Federal Recall Information

817-D

Safety Recall – The Front Axle Sway Bar Links May Be Assembled Incorrectly

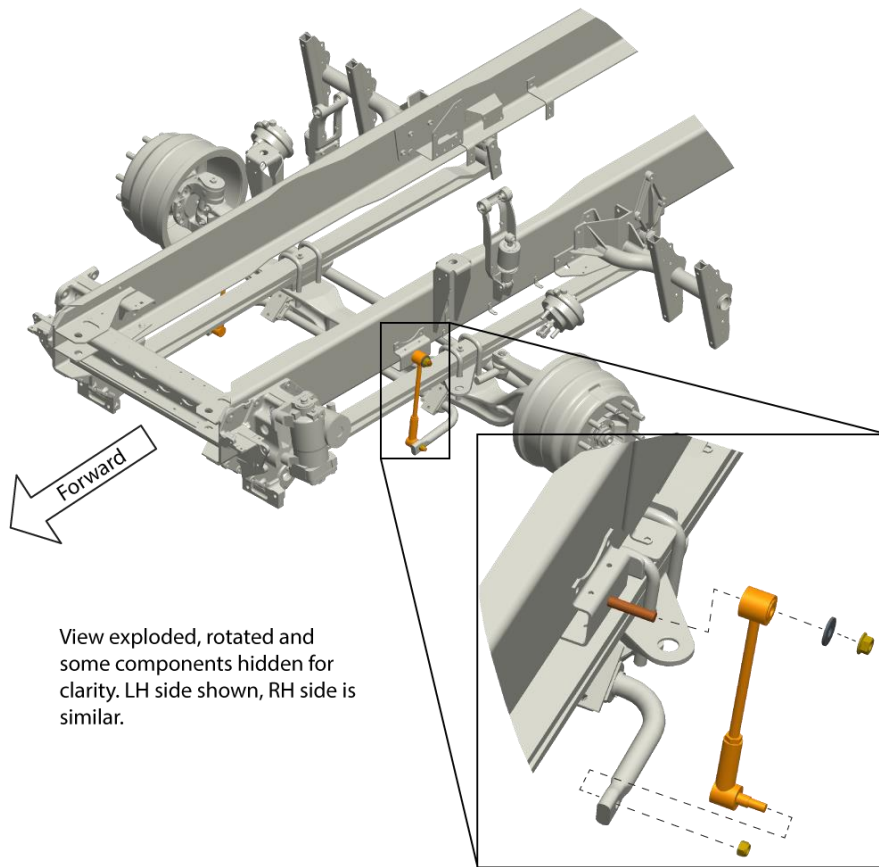
Peterbilt Motors Company has decided that a defect which relates to motor vehicle safety exists in certain model year 2009-2010 Models 220 and 210 vehicles manufactured from March 5, 2008 through April 03, 2009 and model year 2012-2018 Models 330, 337, 220, and 210 vehicles manufactured from March 15, 2011 through August 16, 2017. These vehicles may have a front axle sway bar link assembled incorrectly **on each side of the vehicle**. A missing or incorrectly assembled hardened washer used to attach the front axle sway bar link to the frame rail can result in the sway bar link becoming detached from the frame rail.

Dealers will inspect the upper sway bar link attachment **on each side of the truck** for the presence of the hardened washer between the bushing and the nut, and install the washer if not present or is in the incorrect location.

1. Inspect the sway bar link attachment **on each side of the vehicle** for the location of the retention washer as shown in the images below.
2. Reinstall the hardened flat washer in correct location if assembled incorrectly.
3. If the hardened flat washer is missing, install the hardened flat washer in the correct location.
